MEMORANDUM

DATE: July 2, 2013

SUBJECT: RESULTS FROM CONSULTATION WITH STANISLAUS CAC CONCERNING
PROPOSED CONSTRUCTION OF FUMIGATION CHAMBER

Photo One: Existing exterior

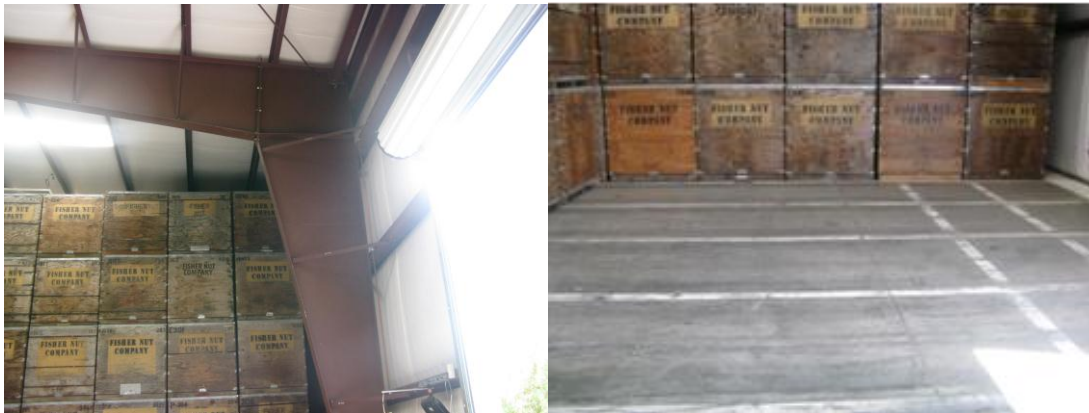
The proposed fumigation chambers are to be located within the confines of an existing steel enclosed structure. The existing structure's walls and ceiling would be modified to become chamber walls and ceiling. An interior wall would be added along the inside of the existing structure, spanning the width of the structure and constituting the rear of the proposed fumigation chambers. This new wall would be a shared wall with an adjoining storage area within the present building envelope. Two additional walls would be constructed within the fumigation chamber area to divide the area into three distinct fumigation chambers. Necessary openings would be added to the exterior walls to allow access to the chambers from the outside. Photo One shows the existing exterior wall. Two more openings would be added to this wall. The present smaller entrance door would be eliminated. No openings/penetrations are presently proposed for the new interior wall.

This proposed structural modification would conflict with 1994 Reference Manual: Methyl Bromide Commodity Fumigation; **Condition 4: Common Wall**. The location of other roll-up doors in the structure appear too distant from the proposed common wall to provide sufficient flow-through of air to dilute/remove any fugitive emissions from the chambers. Likewise, bin stacks in the structure would likely inhibit any passive air-flow ventilation (see Photo Two). So this structure should be considered an enclosed area.

According to the 1994 Reference Manual, potential alternatives to this non-compliance include:

1. Application scheduled when no workers present (test before allowing entry)
2. Pressure-tested chamber
3. Limited access (5 ppm maximum/1 hour time limit; requires testing)
4. Mechanical ventilation with periodic testing
